Groundwater Application Review Summary Form

Application # G- 19460

TO: Water Rights Section Date 9/22/2025
 FROM: Groundwater Section Stacey Garrison
 Reviewer's Name
 SUBJECT: Application G- 19460 Supersedes review of 3/5/2025
 Date of Review(s)

A. GENERAL INFORMATION: Applicant's Name: Clearlake Farms, LLC County: Marion

Cross-Section

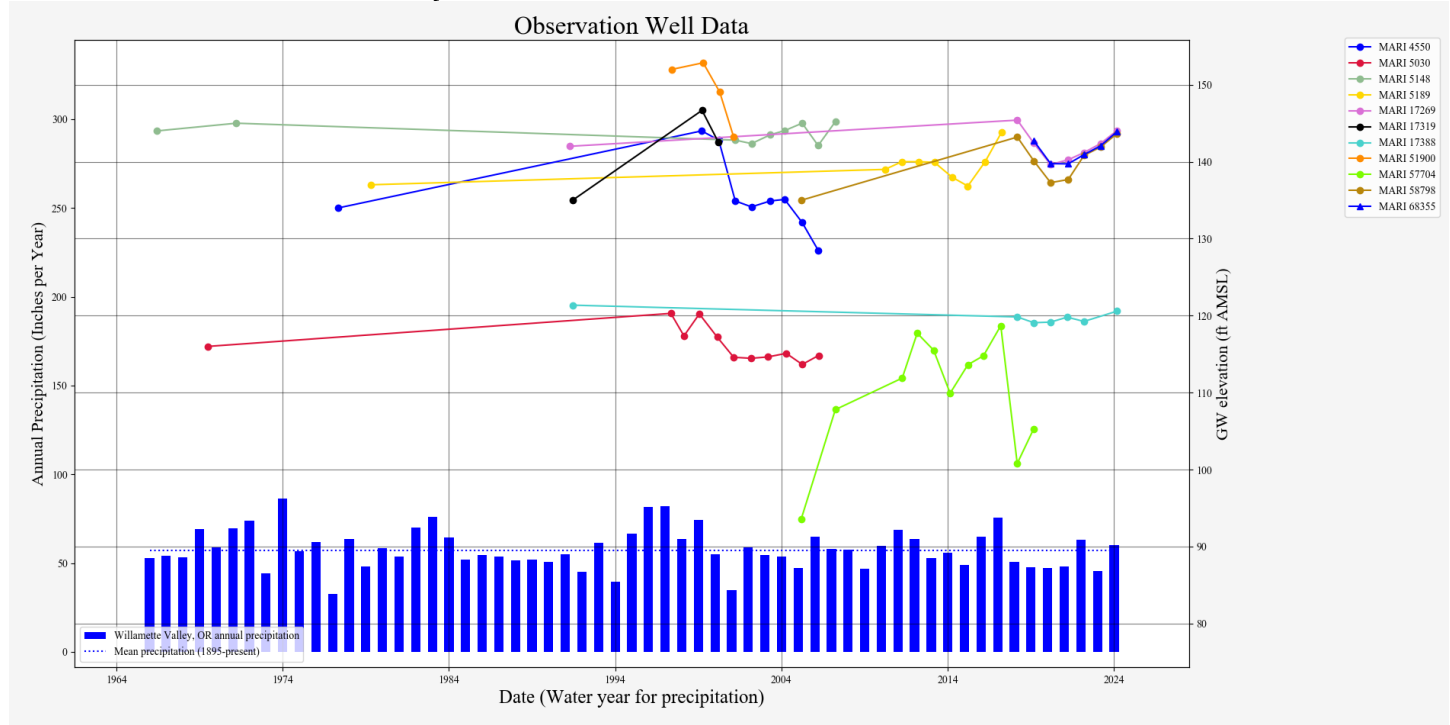
- B3. **Groundwater availability remarks:** The POAs are located on 60 to 80 ft of fine-grained Missoula flood deposits, which overlies the 100 to 120 ft thick Willamette Aquifer that the POAs are likely to develop (O'Connor et al., 2001; Gannett and Caldwell, 1998). Within a mile of the POAs the sand and gravel water-bearing zones, WBZs, of the Willamette Aquifer are between 35 and 400 ft bls [-214 to 129 ft amsl] and range in thickness from 7 to 290 ft^a. A review of statistics for nearby well records was completed and compared with the highest maximum combined rate for the proposed POAs, 3.94 cfs (1,768 gpm) for POA 2 (MARI 5169) from this application (see Well Statistics). The median reported well yield is 50 gpm and the maximum reported well yield is 2,000 gpm; **of the 754 wells included in the statistical review, only six wells are reported with yields exceeding 1,000 gpm and only one well (MARI 5224) reported a yield higher than the lowest combined rate for this application (POA 3/PROP 600 at 1,293 gpm). MARI 5224 was developed to 333 ft deep and with a combined open interval greater than 100 ft thick.** The proposed maximum combined rate for this application is 2,585% of the median and 65% of the maximum reported yield. Within one mile of the POAs, the median well yield is 368 gpm and the maximum is 1,200 gpm. The three POAs that are developed (POA 1/MARI 17388, POA 2/MARI 5169, POA 4/MARI 5170) report significantly lower yields (500 gpm, 700 gpm, and 300 gpm, respectively) than the respective proposed rates of 3,172 cfs, 3.94 cfs, and 2.95 cfs. The undeveloped POA 3 (PROP 600) is anticipated to be deeper than the existing POAs and may encounter additional WBZs that allow it to have a higher yield than the existing POAs. **The proposed rates of use are not likely within the capacity of the groundwater resource.** Water levels are stable (see Water Level Measurements in Nearby Wells). Of the eleven observation wells within one-and-a-half miles of the POAs, four have records over the last five years: MARI 17269, MARI 68355, MARI 58798, and POA 1/MARI 17388. A couple of observation wells show declines between 20 and 30 years ago, however, more recent measurements indicate recovery of water levels since then. There are 57 POAs for 63 groundwater rights within one mile of the POAs, however, the overall steady water levels described above indicate that there is a low likelihood of interference with other groundwater users. The groundwater resource is not likely over-appropriated.

Theis Interference Analysis-POA 1/Johnson Well (MARI 17388)

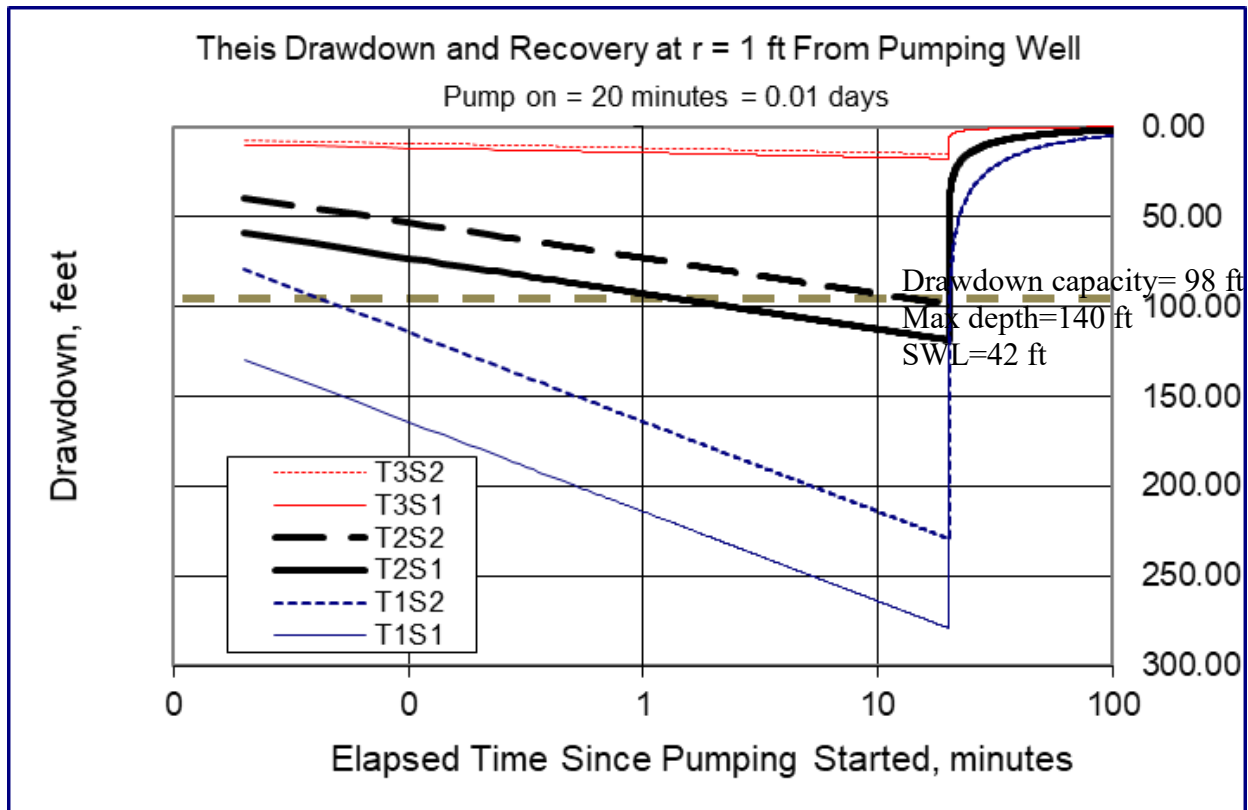
A Theis drawdown analysis on the total drawdown within the pumping well was completed for each of the respective proposed maximum combined rates and compared to the anticipated drawdown capacity for each well. The drawdown capacity was calculated as the most recent static water level minus the maximum depth of the well. Results indicate that the proposed rates are likely to completely dewater the existing POA wells within 30 minutes. Therefore, the proposed use is not in the capacity of the resource.

Theis Interference Analysis-POA 3/Proposed New Well (PROP 600) and MARI 71298

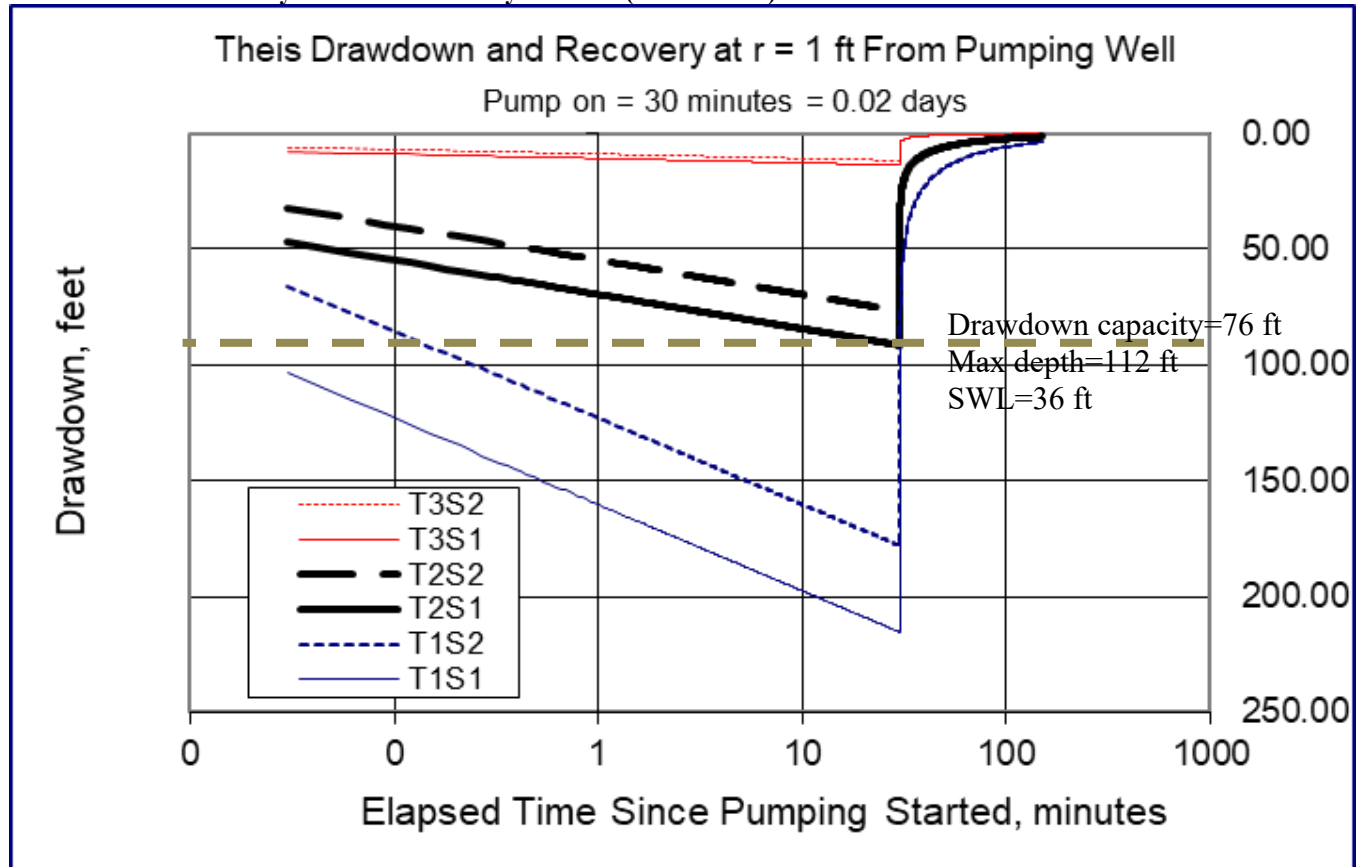
The nearest groundwater user to POA 3/Proposed New Well (PROP 600) is MARI 71298 (an exempt domestic well) located 972 ft southwest and at an elevation of 184 ft amsl. To assess the degree of drawdown, a Theis drawdown analysis was conducted for the proposed use (see attached Theis Drawdown Analysis). **Results indicate that the proposed use is likely to cause well-to-well interference with MARI 71298 that exceeds the threshold under the standard condition for alluvial aquifers in the Willamette Basin within 8 days. Therefore, the proposed use is not in the capacity of the resource.**

Based on this analysis of the available data and under the assumptions previously identified, groundwater for the proposed use is likely not within the capacity of the resource; if a permit is issued for this application, the conditions in B1(d)(i) and B2(c) are recommended to protect senior users and the groundwater resource.
